September 24, 2015 HPO File No. 150923 1809 Summer Street High First Ward

#### CERTIFICATE OF APPROPRIATENESS

**Proposal:** Alteration – In January 2014 the applicant was permitted to wall over the original sash windows on

## **SECOND FLOOR PLAN**

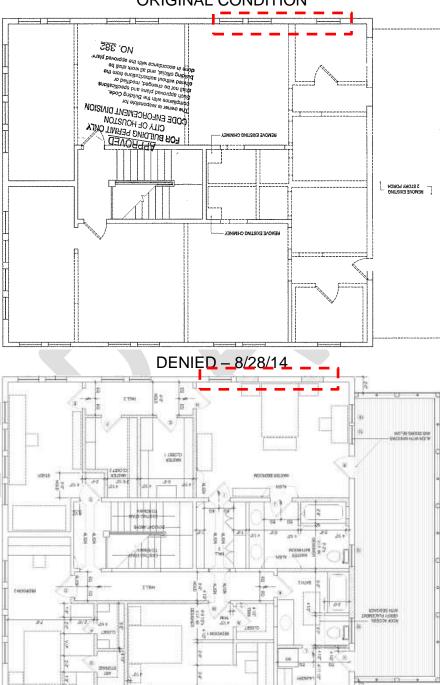
2 existing widows outline in red to be shuttered over

Windows/Doors: The residence features 1-over-1 wood sash windows. Two windows on the second floor at the rear of the east elevation have been walled over on the interior. Wood shutters will be installed on the exterior of two 1-over-1 sash windows that have been walled over. The shutters will be installed over a single 1-over-1 sash window and the rear window in a pair of 1-over-1 sash windows.
